**Subject:** info and action: Transmittal of NRC comments and Slides Regarding August 3, 2021, Version of Industry's TICAP Guidance Document  
**Sent Date:** 8/13/2021 1:17:34 PM  
**Received Date:** 8/13/2021 1:17:00 PM  
**From:** Sebrosky, Joseph

# Technology Inclusive Content of Application Project Public Meeting

**Draft Report Revision E  
Issued for Nuclear Regulatory Commission Review and Comment**

Figure 3.4.N-2. Core Temperature

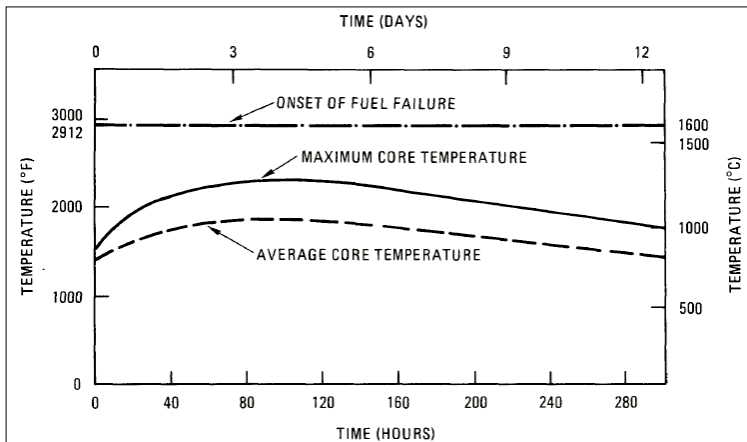
Commented [A116]: Remain subcritical?

Commented [A117]: Values? Time?
